Title - Sujet VENTILATION TOWERS REHABILITATION		
Solicitation No. - N° de l'invitation EP748-141813/A		Amendment No. - N° modif. 004
Client Reference No. - N° de référence du client 20141813		Date 2014-03-27
GETS Reference No. - N° de référence de SEAG PW-\$\$\$FG-356-64724		
File No. - N° de dossier fg356.EP748-141813	CCC No./N° CCC - FMS No./N° VME	
Solicitation Closes - L'invitation prend fin at - à 02:00 PM on - le 2014-04-08		Time Zone Fuseau horaire Eastern Daylight Saving Time EDT
F.O.B. - F.A.B. Plant-Usine: <input type="checkbox"/> Destination: <input checked="" type="checkbox"/> Other-Autre: <input type="checkbox"/>		
Address Enquiries to: - Adresser toutes questions à: Lagacé, Hélène		Buyer Id - Id de l'acheteur fg356
Telephone No. - N° de téléphone (819) 956-0060 ()		FAX No. - N° de FAX (819) 956-8335
Destination - of Goods, Services, and Construction: Destination - des biens, services et construction:

This amendment is raised to issue Addendum # 2 .

CENTRE BLOCK VENTILATION TOWERS
project REHABILITATION PROJECT project
REMISE EN ÉTAT DES TOURS DE
VENTILATION DE L'ÉDIFICE DU CENTRE

SK-1

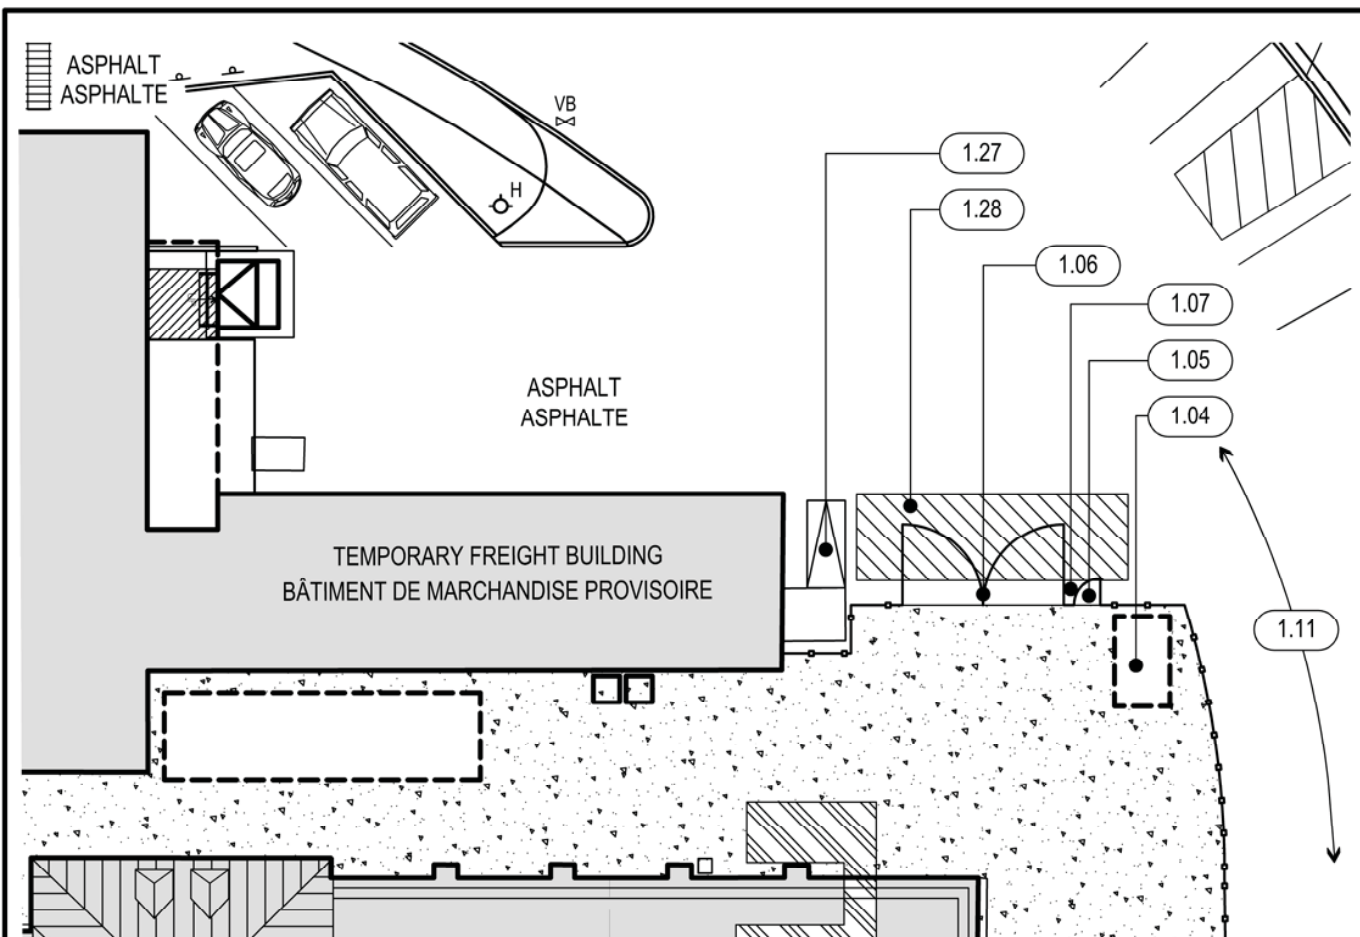
- 1 Refer to sketch SK-1 for modifications to extent of Senate side construction yard perimeter fence.

PROPOSED WORKSITE - SENATE (REVISED)
CHANTIER PROPOSÉ - SÉNAT (MODIFIÉ)

SKE-E2

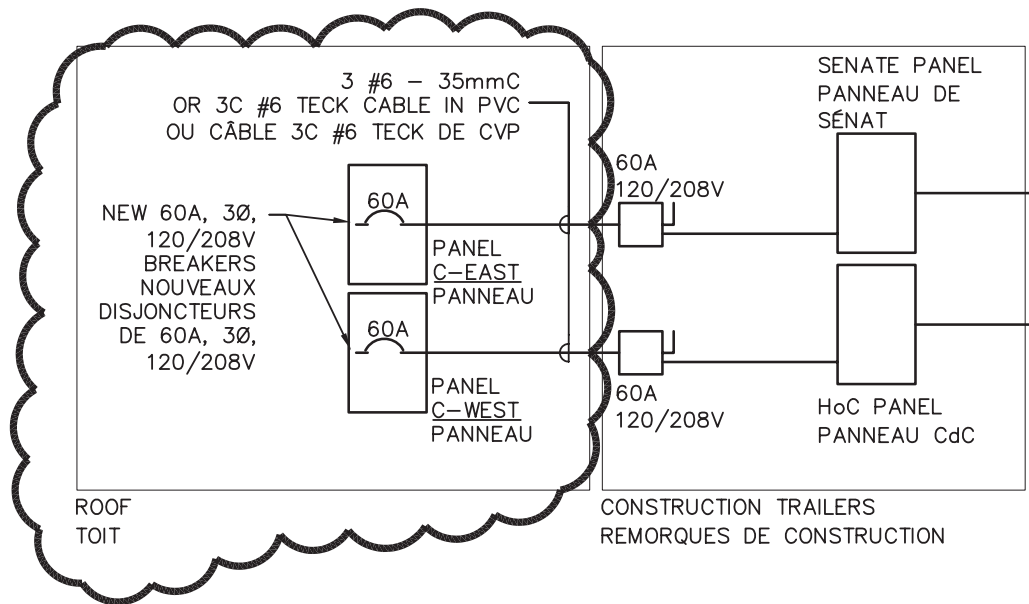
- 1 Refer to sketch SKE-E2 for modifications to the single line diagram.

DRAWING TITLE
PARTIAL SINGLE LINE DIAGRAM
TEMPORARY DISTRIBUTION
DIAGRAMME UNIFILAIRE PARTIELLE
DISTRIBUTION TEMPORAIRE
